DEPARTMENT OF THE NAVY OFFICE OF THE CHIEF OF NAVAL OPERATIONS **2000 NAVY PENTAGON WASHINGTON, DC 20350-2000**

SUBJECT:

BUILDING 150 AND UNDERGROUND STORAGE TANK

DECOMMISSIONING PROJECT, NATIONAL NAVAL MEDICAL

Building 150 (in foreground) circa late March, 1963

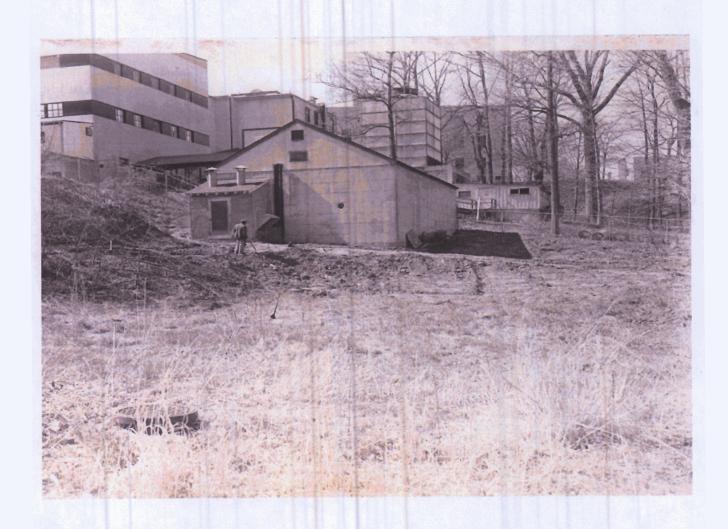
NRC Comment Building 150 drain lines ended about 20 feet from the building. Earlier drain line removal past 20 feet was evident. NRC asks:

Attachment (a) shows Building 150 and the fenced exclusion area surrounding it in early 1963 prior to remediation. The exclusion area was cleared and a dirt road was built to allow truck access the rear of Building 150. Attachment (b) shows the top of Building 150 and the surrounding area that is now overgrown with trees and brush.
